COMMUNITY DEVELOPMENT DEPARTMENT REPORT

HEARING DATE: 12/19/2024

SUBJECT: H-2024-0052
Apex Zenith

D. Concept Plan (date: 10/8/2024)

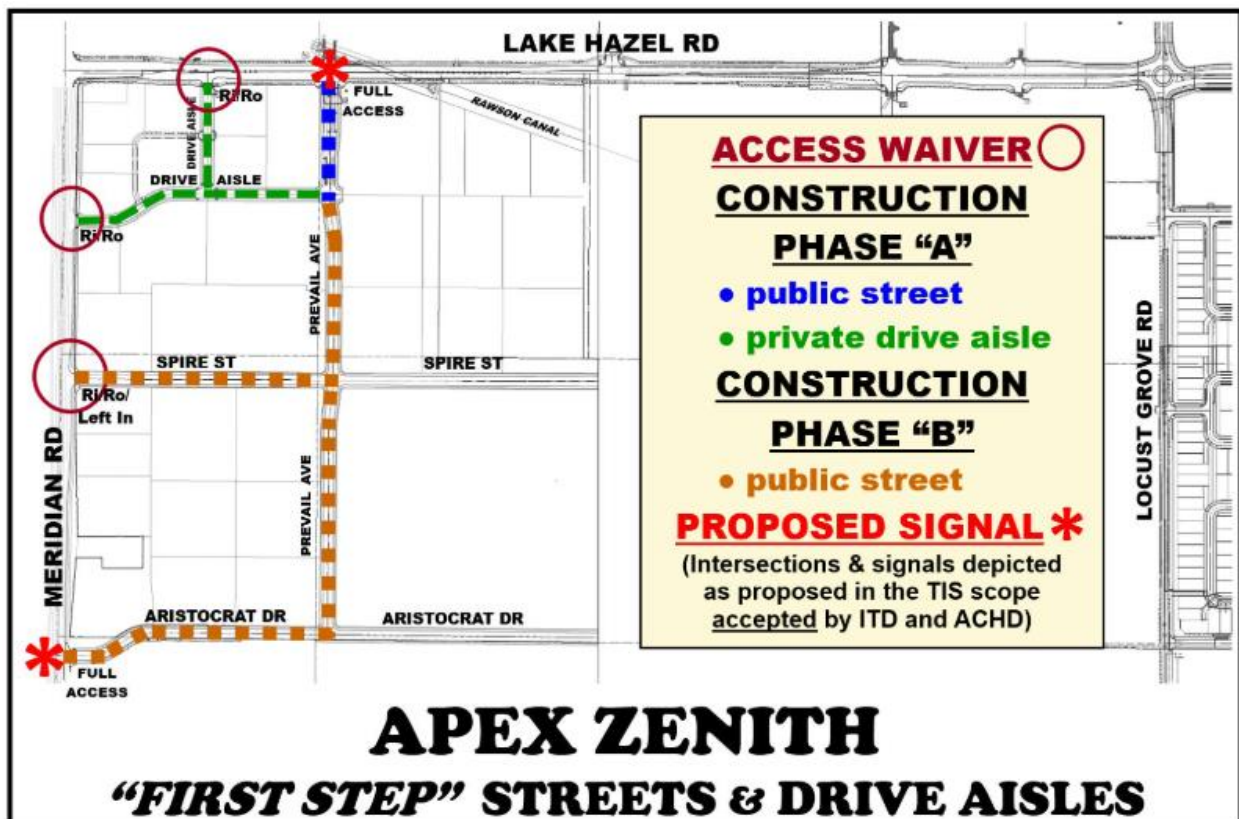
Based on the concept plan, the applicant does not fully comply with the standards outlined in UDC 11-3A-19. While they meet the requirement that no more than 50% of the total off-street parking area for properties over two acres can be located between building facades and abutting streets, they do not meet the building frontage requirements due to the proposed building location.

For mixed-use developments, at least 40% of the buildable frontage must be occupied by building facades or public space. The current concept plan shows no building frontage along Meridian Road. To satisfy the 40% requirement for phase one (1), the applicant should relocate the building to the Meridian Road frontage. Staff recommends sliding the building to the west and positioning it along this road.

However, after discussing with the applicant, they would like to defer the 40% building frontage to phase two (2) with the remainder of the entitlements. Staff has estimated the frontage along Meridian Road is approximately 2,642 feet and the frontage along E. Lake Hazel Road is 2,400 feet. The anchor tenant consumes approximately 700 feet of the frontage along Meridian Road. This leaves roughly 4,342 feet of frontage along Meridian and Lake Hazel Roads with 2,017 feet being required to be occupied by building frontages to meet the 40% requirement. This will be a requirement in the development agreement and will be a key element for the design of phase two (2).

sidewalks are proposed along Spire Street and private drive aisles in the northwest corner. Staff recommends adding 5 feet sidewalks along the portion of the site between the proposed medical offices and future MHDR residential. This will allow the applicant to meet the comp plan goals listed above.

- f. For mixed-use developments, a minimum of 40% of the buildable frontage must be occupied by building facades or public space. The applicant shall either move the proposed anchor tenant building along Meridian Road frontage or provide a minimum of 40% building frontage with phase two.
